Abstract

The design of a daisy chain battery system, while fairly straightforward, has a number of design elements that can become obstacles to implementation. This case study provides a glimpse into the questions and responses in the development of one daisy chain system.

Introduction

FIGURE 1. INITIAL VBAT CONNECTION

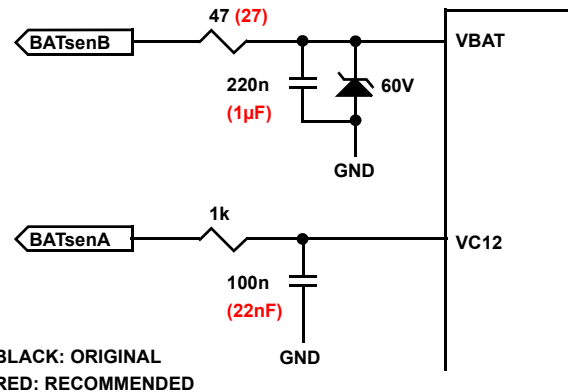
The VBAT input resistor was not damaged. Attached is a schematic of the VBAT connection.

Normally, we recommend a 27Ω resistor. While a 47Ω resistor may be OK, what happens is that the voltage at the VBAT pin drops when there is higher current, like during SPI or daisy chain communications. If the voltage drops too much, then there is not enough headroom on the front end analog circuits and there can be measurement errors. So, if the input resistor is not damaged then try a 27Ω resistor to see if this makes a difference.

If a smaller resistor value does not make a difference, then check that there is no large voltage differential across the VBAT series resistor. There should be a small drop in voltage (up to

about 80mV), however, if there is more than this, check the diode. If the diode is OK and there is still a voltage drop across the resistor, then the part may be damaged.

The schematic shows two connections to the top of the stack, one for VBAT and one for VC12. This is OK, however, check to see if there is a fault condition. If the BATsenB wire is broken, it could affect the measurement accuracy, however, this would also show up as an open VBAT fault.

Another recommendation we make on the input filters is that the time constants on all inputs be the same (or about the same). In this case, the cell input time constant is about 16 times the VBAT time constant. If there are high voltage transients on the pack voltage, the differential time constants will result in high voltage differentials on the IC input pins. To minimize this, we recommend different filter values, as shown in RED in [Figure 1 on page 2](#).

FIGURE 6. CUSTOMER ORIGINAL DAISY CHAIN CONTROL CONNECTIONS

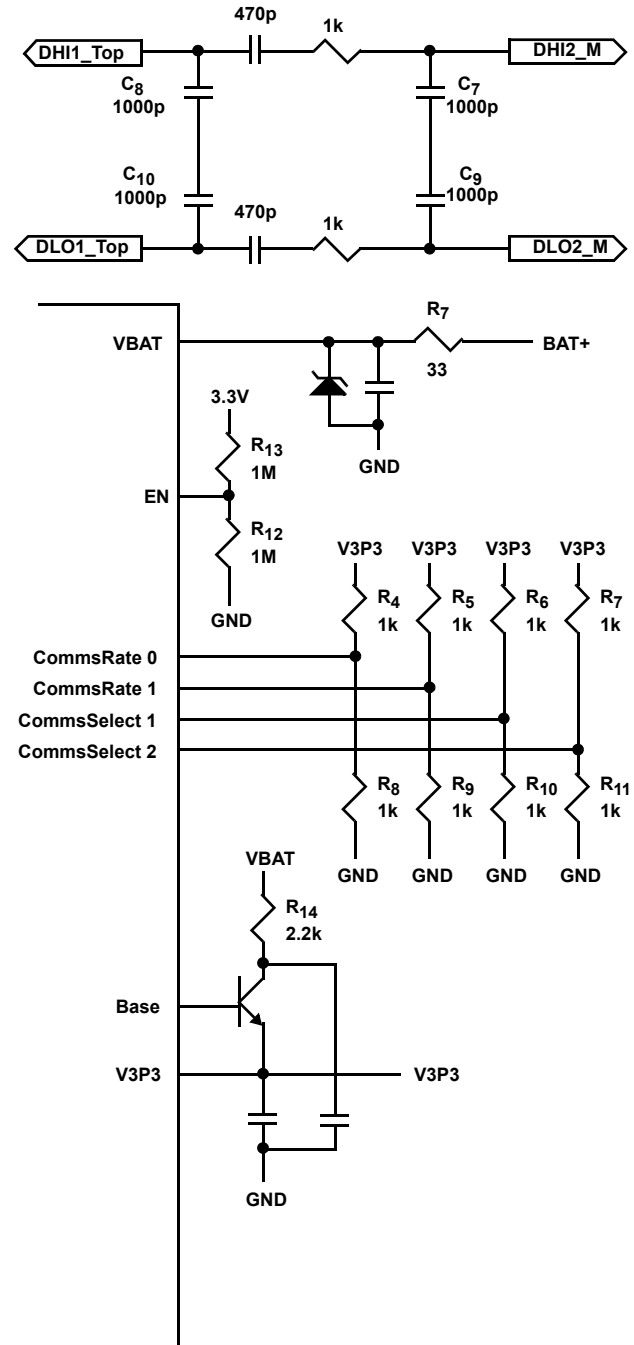
Below (Figure 6) is a schematic of the ISL78600 daisy chain and control circuits in my battery management system.

Resistor R_{12} is not loaded and the Comms pull-up/pull-down resistors are loaded according to the configuration settings above. I measured the voltage across the resistor, R_7 , in the schematic. The master bottom device is currently reading 11.9mV (360 μ A) and the top device is currently reading 2.4mV (72 μ A). Neither of these currents are popping off the datasheet to tell me what is going on.

The first thing to notice on the schematic is that the center point of the capacitors C₈ and C₁₀ (and C₇ and C₉) should be at the respective IC GND (see [Figure 7](#)).

1. Resistor R₁₄ is probably too big. This will work OK for stand-alone, however, because of higher currents in the Daisy Chain mode, it might cause the 3.3V supply to drop out during communications. In our designs, we use a 100 Ω resistor.
2. On the V3P3 regulator, the collector resistor R₁₄ is shown to connect to VBAT. This should connect to BAT+, otherwise the V3P3 current will also flow through R₇, reducing the VBAT voltage.

The observation that current across R₇ is only 360 μA indicates that the device thinks it is a stand-alone device (i.e., Comms Select pins both at 0). Please check this.

FIGURE 8. CUSTOMER REPORTED CORRECT STAND-ALONE COMMUNICATION

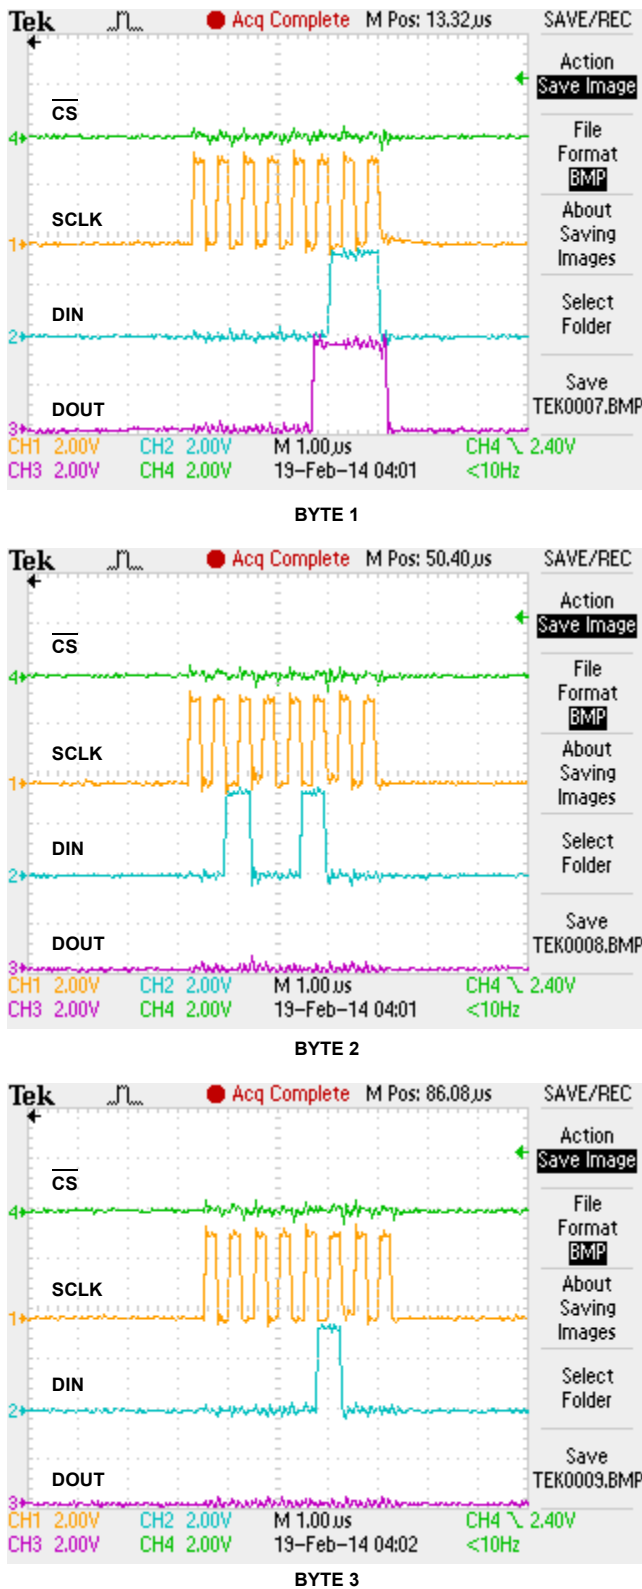
[Figure 8 on page 9](#) shows the SPI Identify command. The MISO data looks like 0x070000 but that's nothing valid to the best of my knowledge. If I send this command a few times in a row, I can get the MISO data to be 0x133800, which looks like a Comms Failure to me.

A: The fact that the upper device does not recognize the sleep/wake commands and there is no movement on the daisy chain lines means that there is something wrong with the daisy chain. *Nothing else matters until this can be cleared up.*

FIGURE 10. CUSTOMER DHI/DLO TRACES

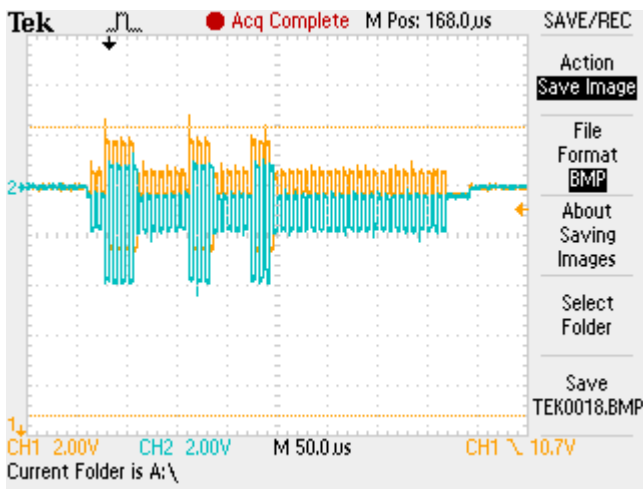
So, that looks good. [Figure 10](#) is the scope waveform for the master/bottom device's DHI2 and DLO2 lines, which actually look correct now while the daisy chain interface isn't connected. DLO2 is blue and DHI2 is orange.

A: The waveform in [Figure 10](#) looks almost correct for daisy chain communications, however, it is still not what you want to see. When the boards properly connect, you should see that the waveforms are more symmetrical vertically; and before and after the signals there should be an offset between the two traces (while here they appear to be the same voltage).

Since the voltages appear good before connecting the daisy chain wires, it looks like there is an isolation problem. Perhaps DHI2 and DLO2 on the top device are being connected to the DHI2 and DLO2 of the bottom device when you connect the two boards with the daisy chain wires. If so, then this would absolutely be a bad thing.

FIGURE 11. RECOMMENDED DAISY CONNECTIONS BETWEEN SEPARATE PCBs (COMPONENTS SELECTED FOR 500kHz DATA RATE)

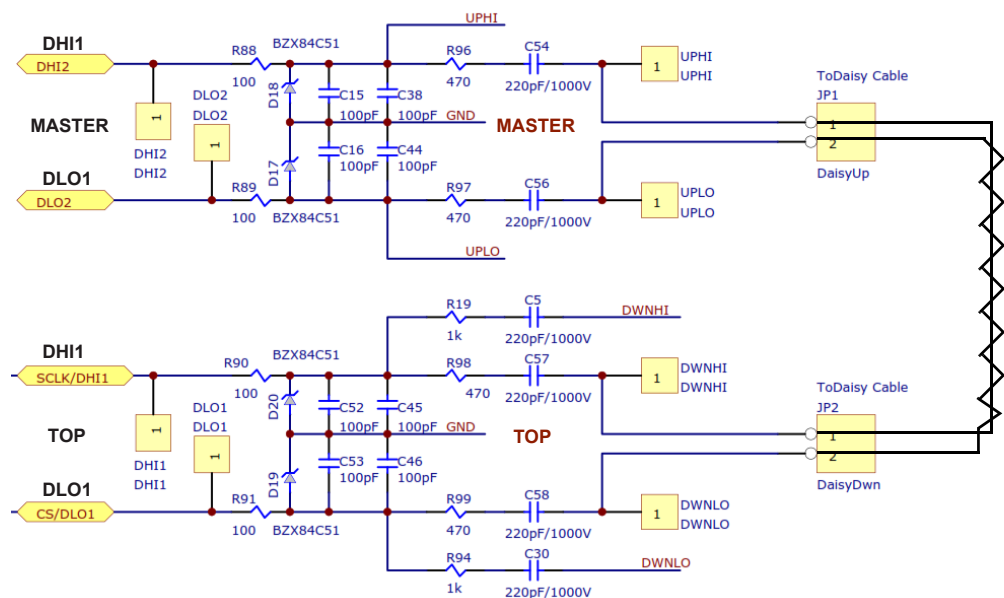
One other recommendation, if you have two boards connected by a cable, we normally recommend a daisy chain connection as shown in [Figure 11](#). This has components for faster daisy chain, however, what you might notice is that the up and down circuits are the same. This arrangement splits all of the components for symmetry, so if there is a break in the cable, the pins are isolated on both sides of the break. Even with a direct connection, this arrangement means that you do not need to bring the ground on the high side capacitors through the connector.

FIGURE 12. CUSTOMER DAISY WAVEFORMS AFTER CHANGES (GOOD)

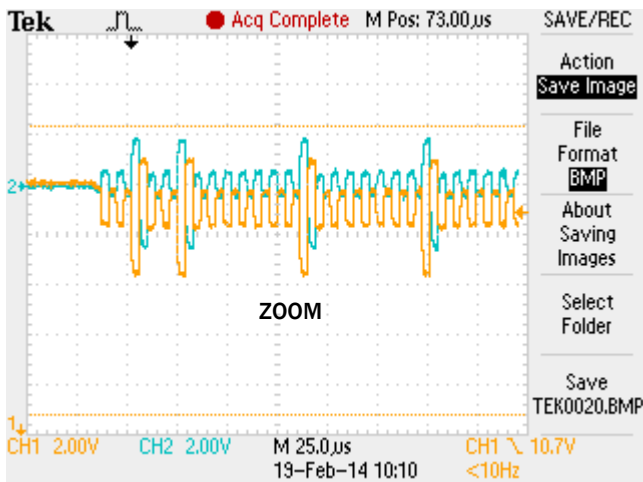
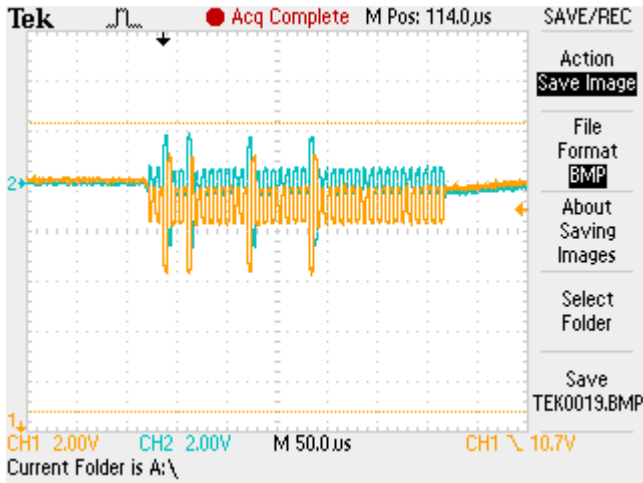
Q: Wow, it's been a long day. I think I finally got it right, however, I won't be able to check if valid data is coming back down the stack until tomorrow. [Figure 12](#) are two waveforms showing my daisy chain communication. What I sent you last time was just the master/bottom side, since connecting them had the isolation issue I described. Once I fixed the isolation issue, I connected the 2-wire daisy chain interface and captured the attached waveforms.

A: This looks better.

FIGURE 13. CUSTOMER BASE ID COMMAND (SPI)

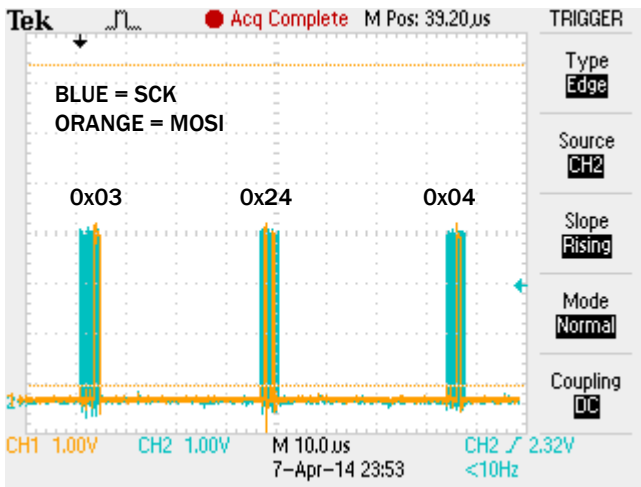
The 'base id command' waveform (Figure 13) shows the transmission of 0x03 24 04 from the Host MCU to the bottom/master device, specifically, the timing between SPI bytes in the overall transmission of this command. The timing shows that this command meets the 100µs maximum requirement defined as the \overline{CS} high time (the time between bytes). Please let me know if you see any concerns with the timing of my command transmission.

FIGURE 14. CUSTOMER DATA READY RESPONSE HANDLING TIMING

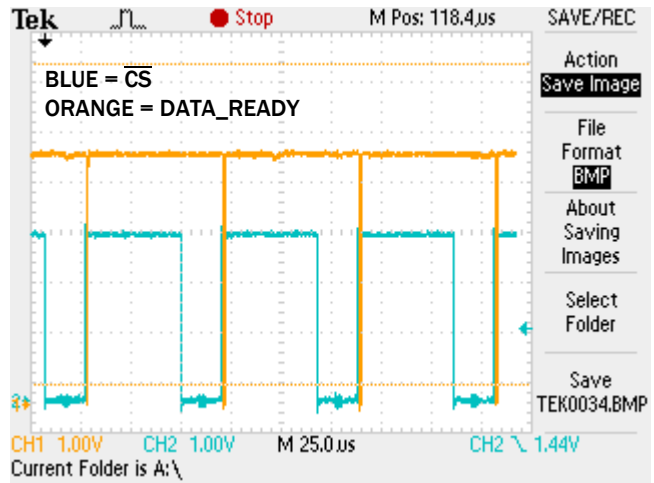
Also, the 'data_ready response handling' waveform (Figure 14), shows the timing on servicing the $\overline{DATA_READY}$ line. Please note that I have a level shifter that inverts $\overline{DATA_READY}$ from the ISL78600. As shown in the waveform, the $\overline{DATA_READY}$ signal goes HIGH when a byte is available in the ISL78600 buffer. The time that \overline{CS} is low is the time it takes for me to read a SPI byte (~25µs). At the completion of each read with the rising edge of \overline{CS} , you can see $\overline{DATA_READY}$ dip low briefly and return HIGH, indicating another byte is available. The time from the rising edge of $\overline{DATA_READY}$ to \overline{CS} going low again is the time it takes for me to respond to the $\overline{DATA_READY}$ signal (~45-50µs). Do you think this is too long?
